# Sudden Valley Community Association Architectural Control Committee

Date 07/16/2026

Type of meeting: Request and Plan Review

**SITE PLAN**  
 SCALE: 1" = 10'-0"

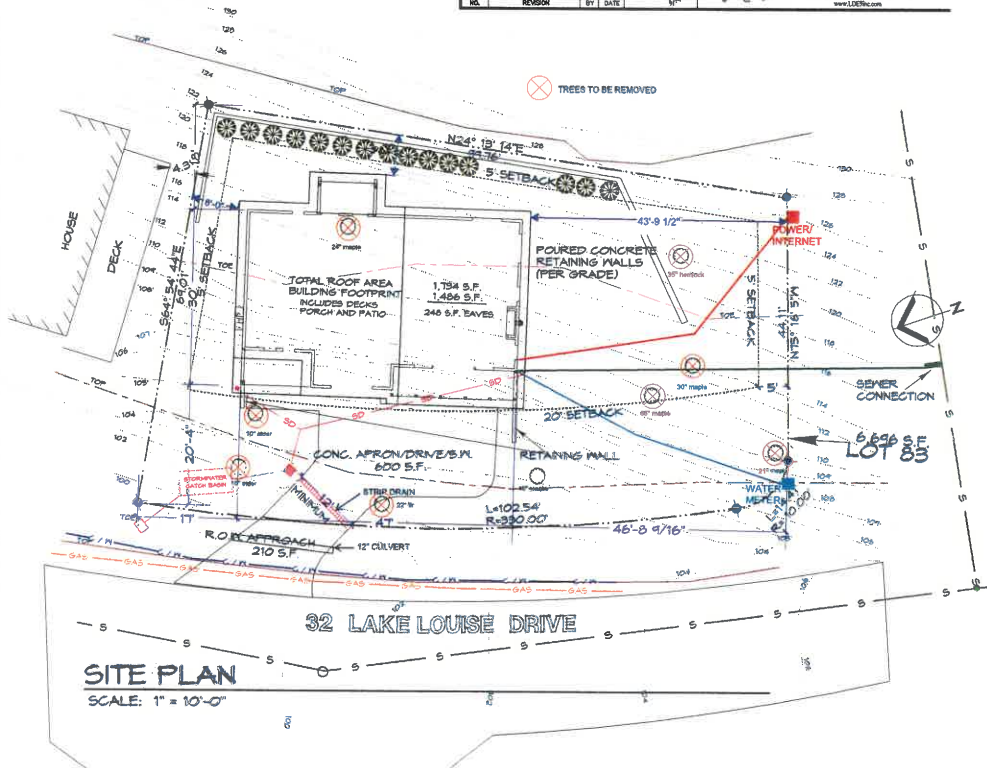
Item - 9	32 Lake Louise Dr, G2, New Construction		Video 01:15:56 - 01:39:05
Comments:	Provide an Arborist Report on the likelihood of survival of the trees impacted by the Utility Connections. Provide stamped & signed Engineering Plans on retaining wall. Provide overview of Utility connections.		
Discussion:	Require either moving the house or getting a letter from the neighbors saying that the design and size are acceptable to them.		
Action:	Denied	Motion: Dan	Unanimous
